HISTORIC PRESERVATION COMMISSION

REQUEST FOR CERTIFICATE OF APPROPRIATENESS

MPC File No.: 25-005239-COA

Address: 215 West Anderson Street

1916 Sanborn

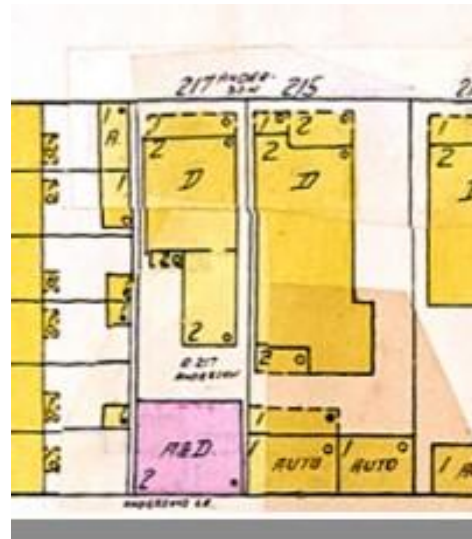
The porch was not originally present. The 1953 Sanborn map shows significant changes and updates made from the original.
